Access Compliance Report

Public Rights-of-Way

(Curb Ramps)

Intersection ID: N/A	Main Street: S_CLARKSON_ST	Cross Street: POST_ST	Location: E
ADA ID: 2D2D2C76D504	Ramp Type: Perp	Initial Pass/Fail: Fail	Overall Compliance: No
Severity Score: 8.75			
Codes/Mitigation Info/Possible Solution		Field Measurements/Component Compliance

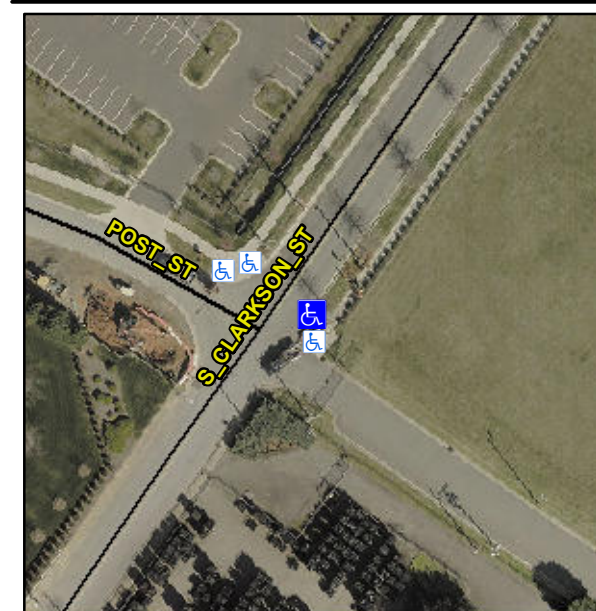
Not Found, R304.5.1

Compliance	Description	Data	Compliance	Description	Data
N/A	Ramp Length (in)	96.0	Yes	Ramp Slope (%)	7.4
No	Ramp Width (in)	47.0	Yes	Ramp XSlope (%)	1.4
N/A	Flare Type LT	N/A	N/A	Flare Type RT	N/A
N/A	Flare Slope LT (%)	N/A	N/A	Flare Slope RT (%)	N/A
N/A	Flare Traversable LT?	N/A	N/A	Flare Traversable RT?	N/A
N/A	Landing Length (in)	N/A	N/A	DWS Provided?	N/A
N/A	Landing Width (in)	N/A	N/A	DWS Contrast?	N/A
N/A	Landing Slope (%)	N/A	N/A	DWS Length (in)	N/A
N/A	Landing X Slope (%)	N/A	N/A	DWS Full Width?	N/A
N/A	Landing Curb? (Y/N)	N/A	N/A	DWS Offset (in)	N/A
N/A	Shared Landing?	N/A			
N/A	Gutter Ponding?	N/A	N/A	Gutter Slope (%)	N/A
N/A	Gutter Lip Ht (in)	N/A	N/A	Gutter X Slope (%)	N/A
N/A	Painted X Walk1?	No	N/A	Painted X Walk2?	N/A
	X Walk 1 Direction	To NW		X Walk 2 Direction	N/A
N/A	X Walk 1 Width (in)	N/A	N/A	X Walk 2 Width (in)	N/A
	X Walk 1 Slope (%)	2.9		X Walk 2 Slope (%)	N/A
	X Walk 1 X Slope (%)	3.7		X Walk 2 X Slope (%)	N/A

Remove & Replace Entire Ramp.
